Subject: REAR CONSOLE LID STICKING AND SQUEAKING WHEN OPENING AND/OR CLOSING	Bulletin No.: 09-025/22
	Last Issued : 08/01/2022

2019-2022 Mazda3 (Japan built) with VINS lower than JM1BP*****510095 (produced before December 22, 2021)

2019-2022 Mazda3 (Mexico built) with VINS lower than 3MZBP*****220473 (produced before December 22, 2021)

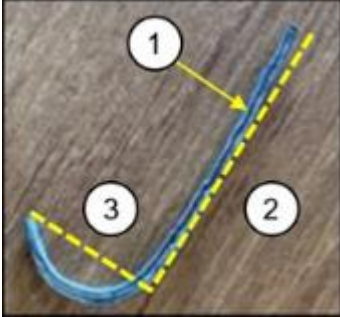
Some vehicles may exhibit a rear console lid with a sticking feeling or a squeaking noise when opening and/or closing. This is caused by an inappropriate shape of the console lid hinge pin where the position of the hinge pin (1) becomes misaligned when the rear console lid is repeatedly opened and closed. When parts around the hinge pin thermally expand, the result creates a gap in the hinge of the rear console lid.

To eliminate this concern, the shape of the hinge pin has been modified to prevent the pin from coming off.

Before modification

After modification
